**Environmental
Planning
Commission**

**Agenda Number: 05
Project Number: 1008444
Case #s: 13EPC-40159
February 13, 2014**

Staff Report

The Planning Department requests an Environmental Planning Commission (EPC) recommendation to City Council to approve text amendments to the West Side Strategic Plan (WSSP) for the Volcano Mesa community.

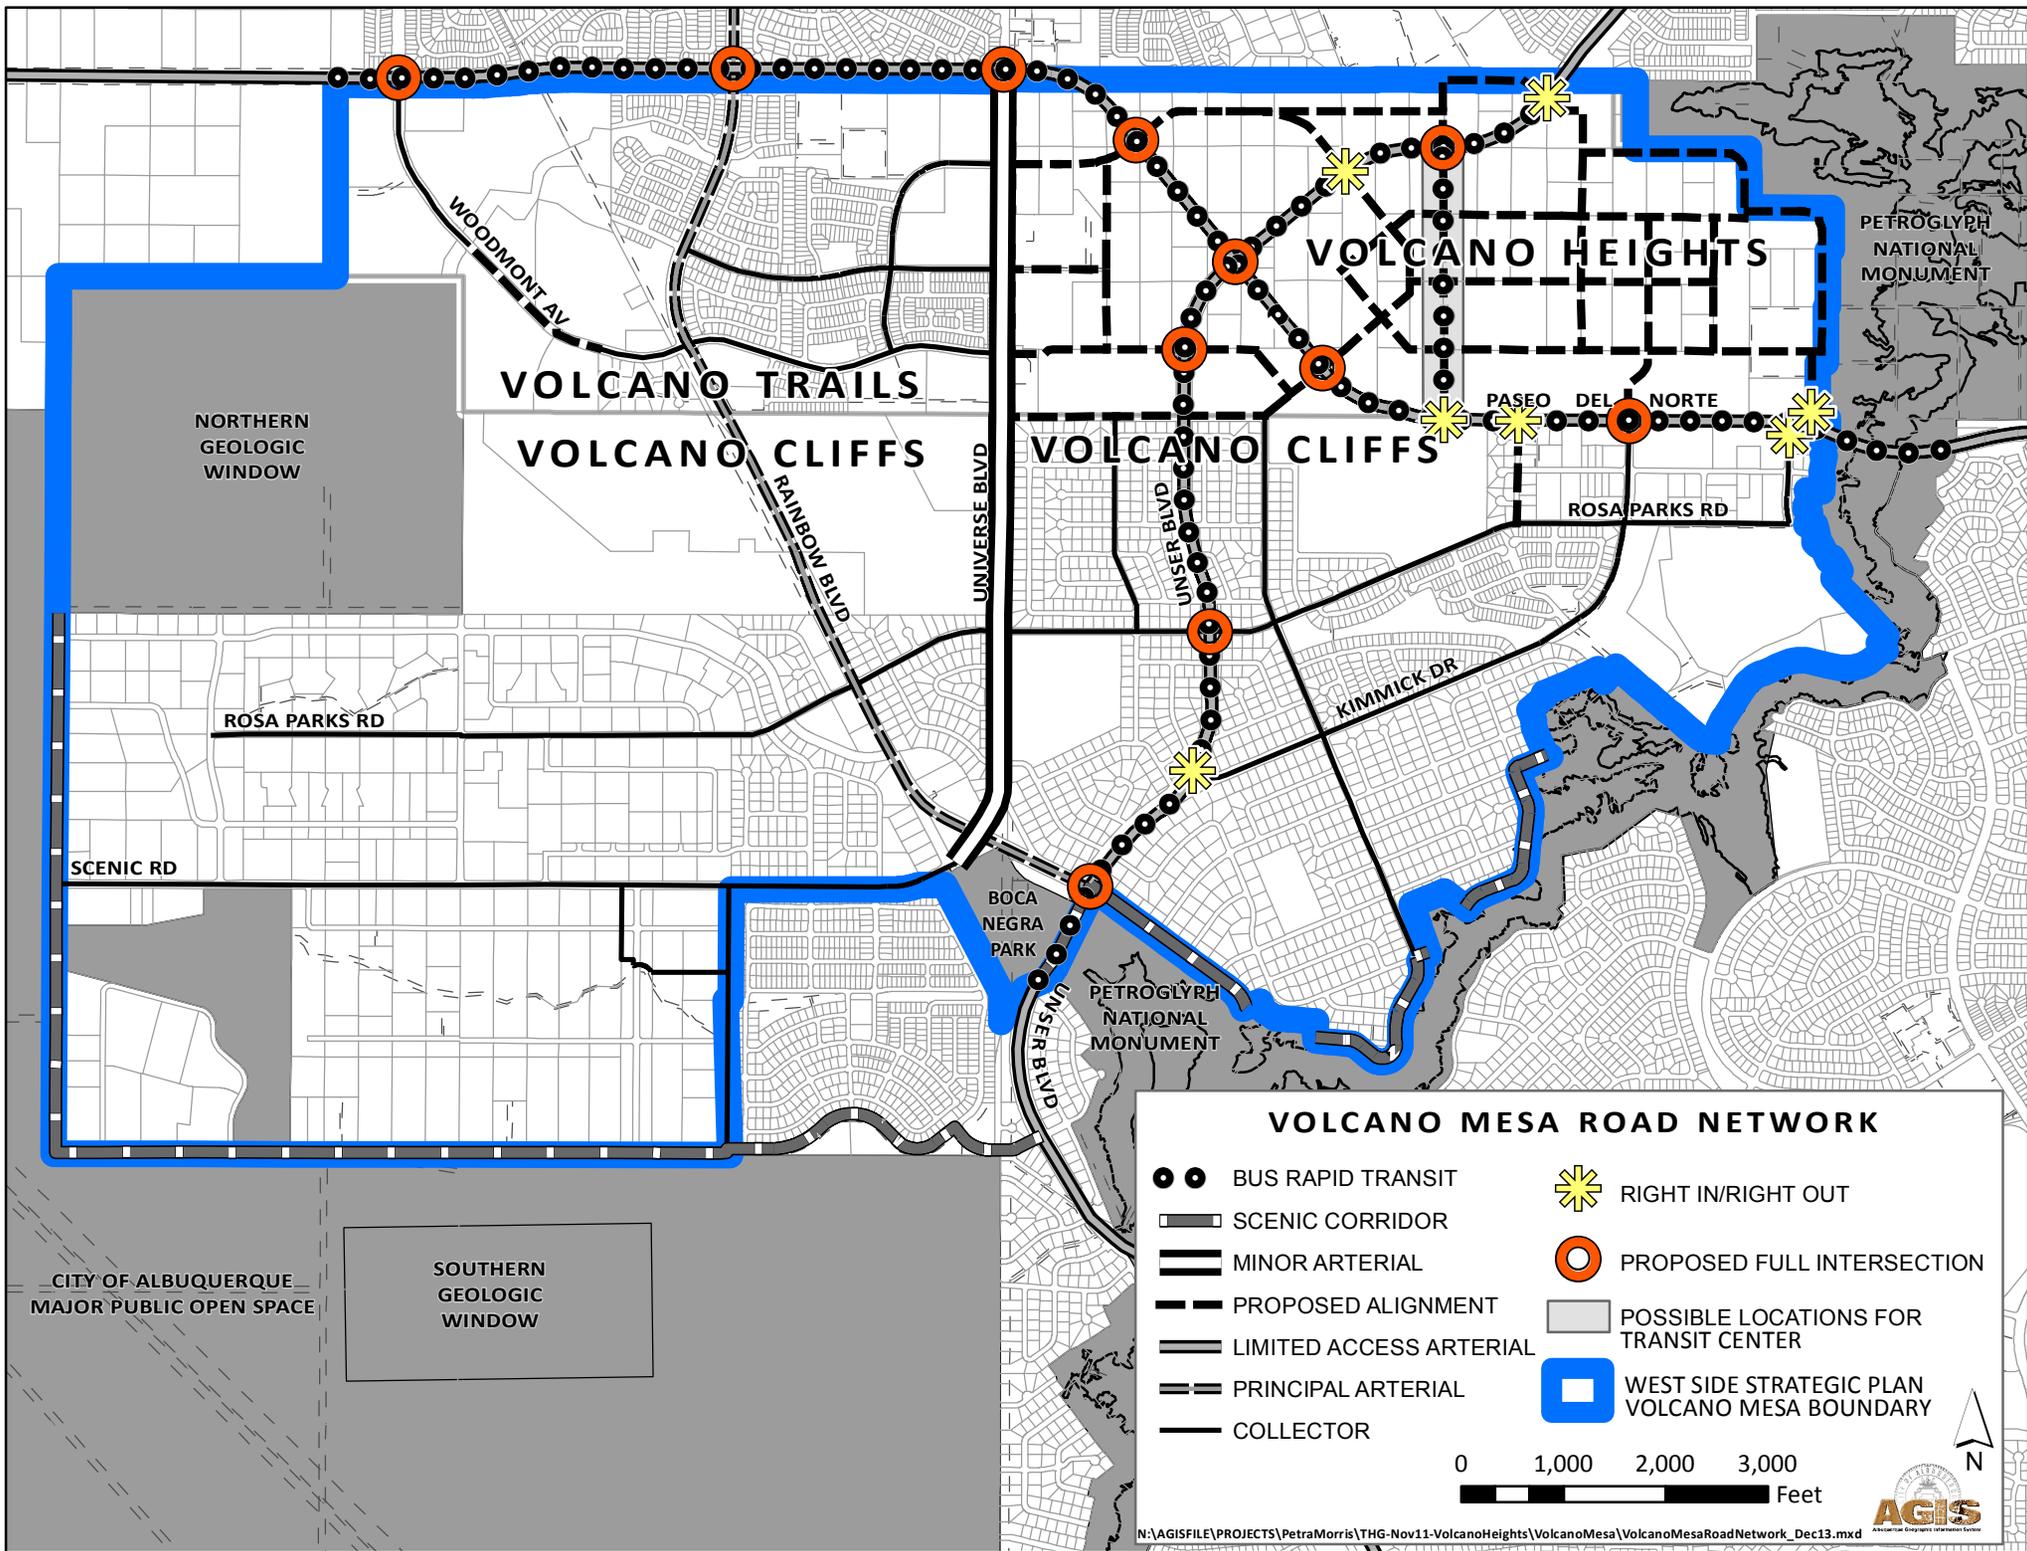
PUBLIC SERVICE COMPANY OF NEW MEXICO

Underlined text indicates added language and strike-through text indicates deleted language.

1. Add a section to Policy 3.98. Implementation Strategies... at the top of page 4 of the Volcano Mesa Amendment, "Electric" with the following language:

Electric. Electric infrastructure is planned and constructed in response to new development. New electric transmission lines and multiple substations will be needed within the Volcano Mesa area to provide electric service once regional employment center development occurs. Substations typically require two-acre parcels of land. It may be necessary for substations to be located near the electric load in the Plan area. Transmission lines should be located along arterial streets, major drainage channels, non-residential collector streets and other potential corridors as directed by the Facility Plan: Electric System Transmission and Generation (2010-2020).

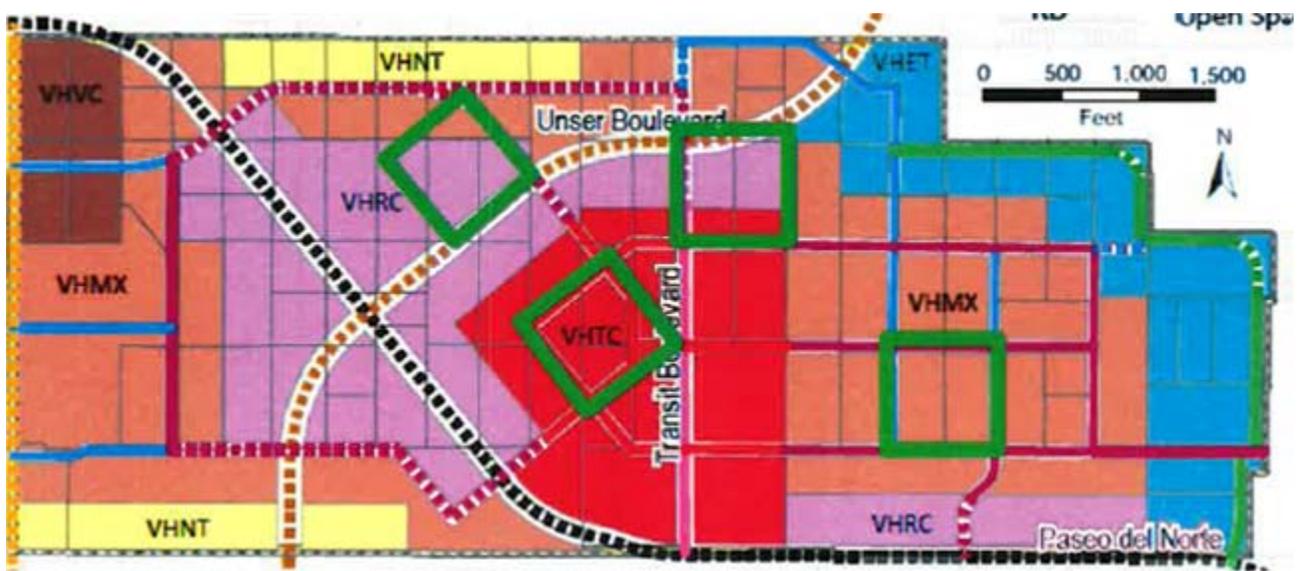
10. Page 197 – I do not agree with section 10.7.2 and table 10.2. Please refer to the figure below that shows four different square ~10 acre parcels (~660' x 660'). Two parcels contain regional center zoning that is supposed to allow more auto oriented use, one parcel is mixed use, and one parcel is town center. If one looks at the two parcels with regional center zoning the corner adjacent to the two "B" streets (Unser Blvd and transit Rd / Loop Rd) would be the most desirable corner for auto oriented uses. However, one is to access this corner via an internal "B" street, then any other internal street within the regional center would need to be an "A" street with the associated "A" streetscape to meet the requirements of table 10.2. Conversely, if one looks at the mixed use or town center parcel which are completely surrounded by "A" streets, internal auto oriented "B" streets can divide these parcels into four smaller parcels (each ~330' x 330') while meeting the requirements of table 10.2. It is counter-intuitive that the more pedestrian oriented town center can be built out with more auto-oriented "B" street flexibility than the regional center zones which are supposed to be more auto-oriented.

This situation arises because Unser Blvd. and Paseo del Norte are classified as "B" streets. While these two regional highways are definitely auto-oriented, they are limited access roadways that do not provide direct site access. Both Unser Blvd. and Paseo del Norte also have "A" street characteristics such as bike lanes and multi-use trails.

I fully support that the entire plan area should incorporate features to create a walkable environment; however, in order to avoid the problems cited above, Unser Blvd. and Paseo del Norte should be classified as "A" streets for determining the percentages in table 10.2.
